CONSTRUCTION PERMIT

City of Appleton City
Appleton City Wastewater Treatment Facility
114 East 4th Street
Appleton City, MO 64724

City of Appleton City
Facility Plan – **Memorandum**

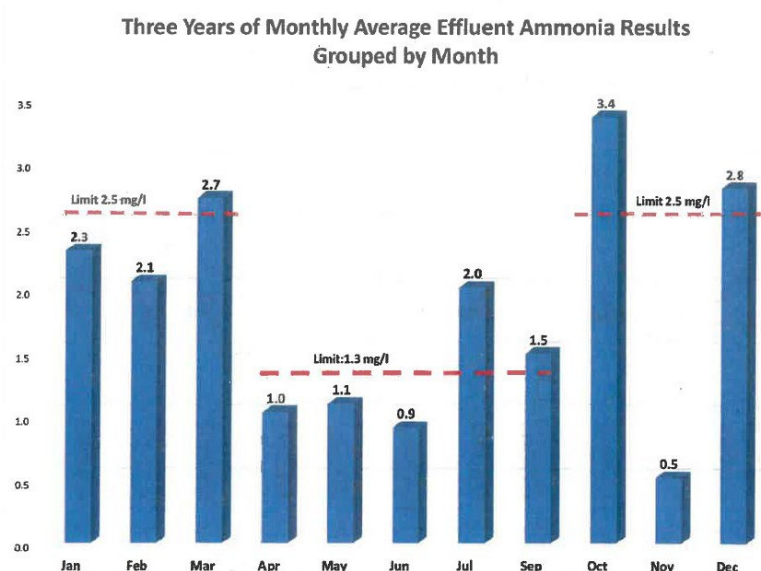
Comment 3: Additionally, how will the low temperatures in winter as well other water characteristics (such as alkalinity) be addressed that can have an impact on the ability to remove ammonia? Provide this information as an addendum to the facility plan.

Comment 3 Response: Low temperatures, as shown in the DMR data from 2018 – 2021 below, do slow the ammonia removal efficiency. However, the lagoon system shows that meeting ammonia limits during the winter months is achievable with the current system. The removal of the excess sludge is expected to improve the lagoon efficiency overall. The EPA conducted a study and reported that at 20 degrees Celsius (68 degrees Fahrenheit), there is a 90 to 95% ammonia removal efficiency, while at 10 degrees Celsius (50 degrees Fahrenheit), efficiency decreases to 75 percent removal (EPA 832-F-00-019). DMR data for the City of Appleton City available for one winter sampling event, December 31, 2022 is examined here. Influent ammonia concentration was measured at 42.6 mg/L. 75% removal of that concentration is 10.65 mg/L; effluent concentration for the same sampling event was 10.69 mg/L. The current system, without improvements, achieves this projected removal. This is over the daily maximum effluent limit of 10.1 mg/L, but with the removal of sludge in the lagoon, effluent ammonia concentrations are expected to decrease.
